Non-Concurrence Process Record for NCP-2011-014

TITLE OF DOCUMENT South Texas Project Combined License Application Review: SER with No Open Item Chapter 2.4	ADAMS ACCESSION NO. ML 111450749
DOCUMENT SPONSOR Nilesh Chokshi, Deputy Director, NRO/DSEB	SPONSOR PHONE NO. 301-415-1634
NAME OF NON-CONCURRING INDIVIDUAL Hosung Ahn	PHONE NO. 301-415-1398

Attachment 1: Reasons for Non-Concurrence

Title: South Texas Project Combined License Application Review: SER with no Open Item
Chapter 2.4

Figure 4-1. Cross section of the MCR embankment levee (provided by STP)

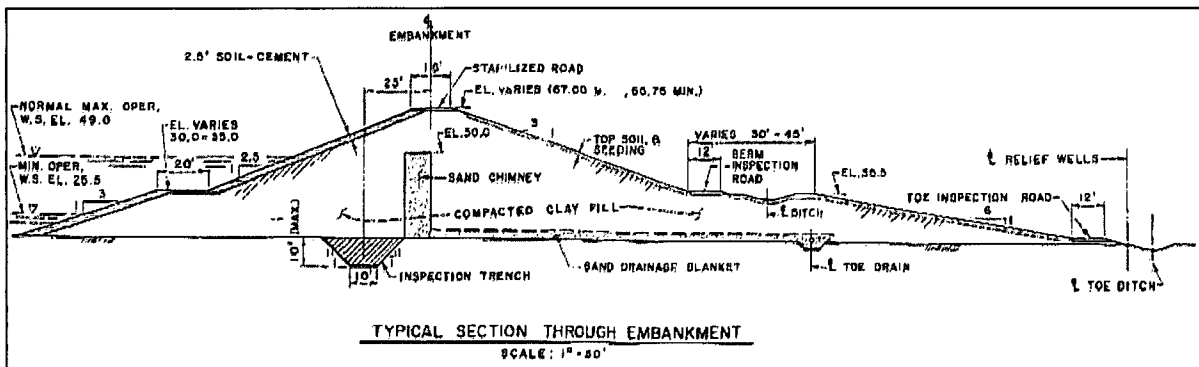
The MCR embankment levee was built with 40-foot-high rolled soil materials above the clay-sand-silt top surface. The interior face (reservoir side) of the dyke is lined with 2 ft thick soil cement blocks to absorb wave actions. The outside face of the levee is covered by grass on bare soils (refer to Figure 4-1). The design normal maximum operating water level in the MCR is 49 ft MSL. STP postulated the MCR dyke failures caused by the excessive seepage from: (1) piping through the foundations of embankment, (2) seismic activity leading to liquefaction of the foundation soils, and (3) erosion of the embankment due to overtopping or wind-wave events.

Figure 6-1. Comparison of MCR breach analyses by STP, PNNL, and the author.

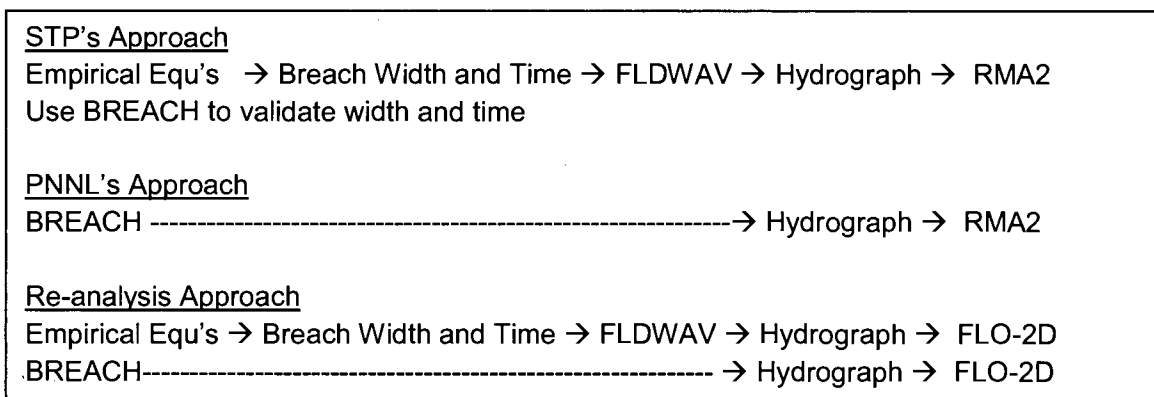
Because the RMA2 model which was used by STP that is not available to the NRC staff, the author used the FLO-2D model which is another numerical 2-dimensional hydrodynamic flow routing software. The following figure compares the different modeling approaches used for the MCR breach flood analysis. The following subsections describe details of each step in the re-analysis.

Figure 6.4-1. The relation between Manning's n-value and breach peak outflow obtained from BREACH simulations (without scour hole effects).

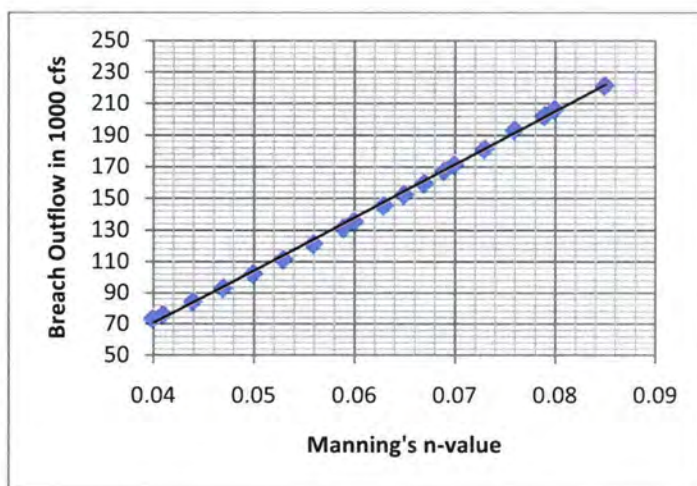
PNNL (2011) selected n-value of 0,075 without justification. PNNL performed a sensitivity analysis, but part of their sensitivity analysis is erroneous due to a faulty BREACH setup. Therefore, the author investigated the proper n-value for the MCR breach, followed by a supplemental sensitivity analysis of the MCR BREACH model.

- The BREACH model predictions are very sensitive to n-value. This was also noted in the PNNL's calpack and Figure 6.4-1.
- The BREACH model predictions are very sensitive to the scour hole depth. The effective of scour hole is nonlinear - The peak outflow rates increase with increasing hole depth. The flow rates are peaked (271 kcfs) at the hole depth of 15 feet, then decrease thereafter. It seems that this peak flow is the probable maximum MCR breach outflow, if scour hole is considered in the breach process.
- Both peak time and breach width is inversely proportional to the hole depth. The deeper the scour hole is, the more the initial breach outflows is. However, scour hole reduces breach width. In conclusion, considering the effects of breach scour hole induce high peak breach outflows and more severe flood hazard than without considering it.

Figure 6.6-9. The best-fitted and envelop regression lines in predicting breach width (after Wahl, 1998).

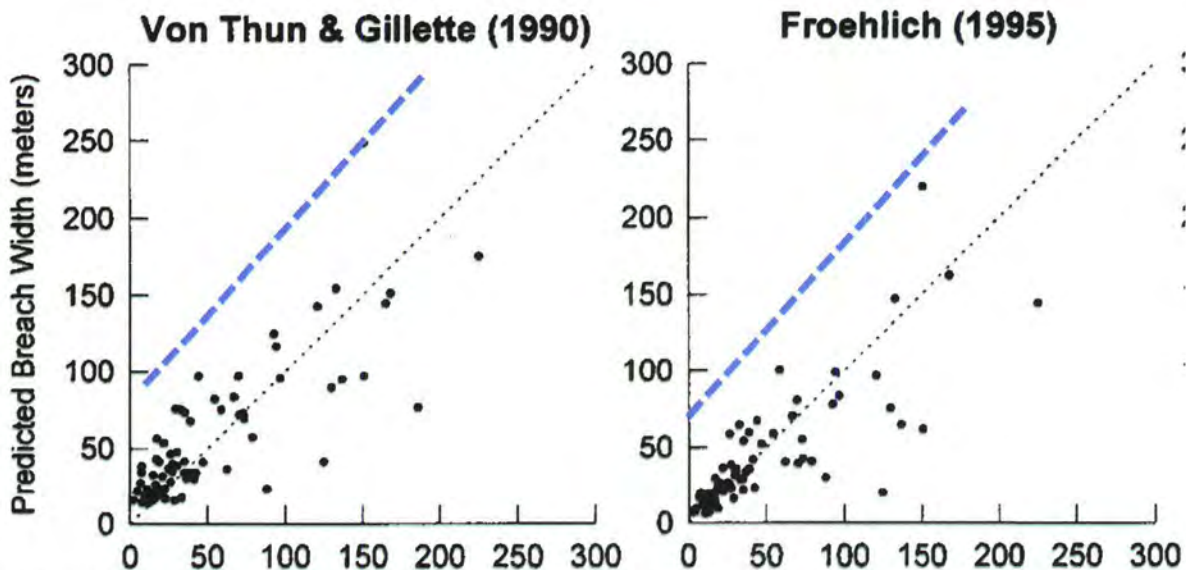
The breach parameter estimates in Subsection 6.3 are based on the best-fitted linear regression line shown (dot lines in Figure 6.6-9). The problem in using the best-fitted line is that about a half of historical breach records would exceed the best-fit estimate – This expected value result in an underestimation. If an extreme conservatism is of concern, one may use a bounding (dashed envelop) line equations. On this regard, the following three extreme scenarios were postulated:

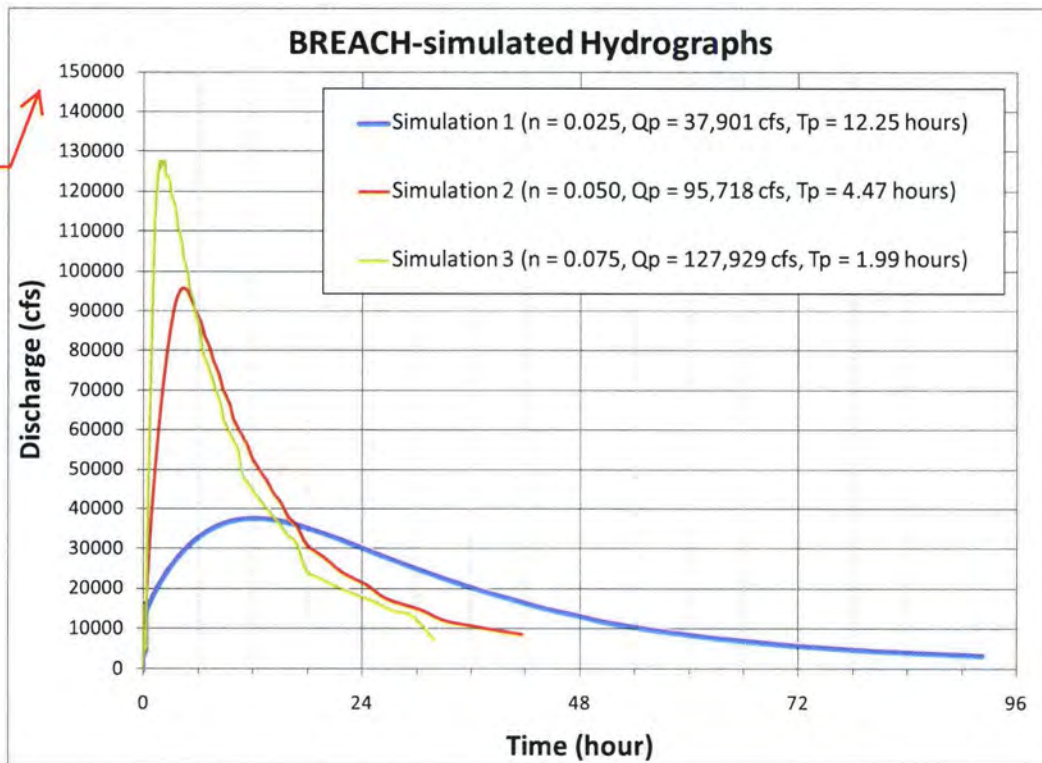
This graph needs to be corrected with correct simulation result.

Figure 6.3-2. The ¹ best-fitted MLM breach time regression line that was obtained with the dam breach data provided by the MLM paper (1984).

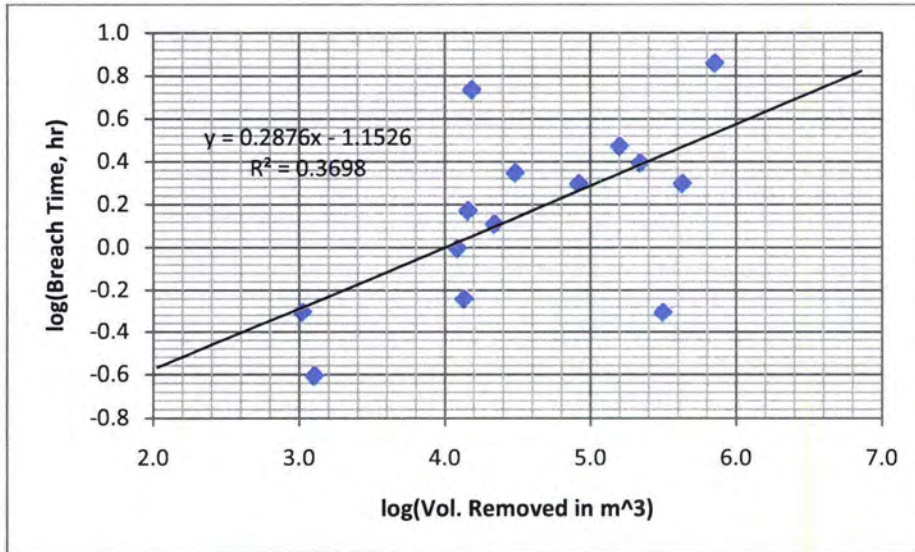
-  Number: 6 Author: D3K890 Subject: Inserted Text Date: 7/14/2011 7:35:53 PM -04'00'
equation
-
-  Number: 7 Author: d3b102 Subject: Comment on Text Date: 7/12/2011 10:36:57 AM -04'00'
Which equation does this refer to? It sounds like a NRC result? Is it the equation on the figure below?
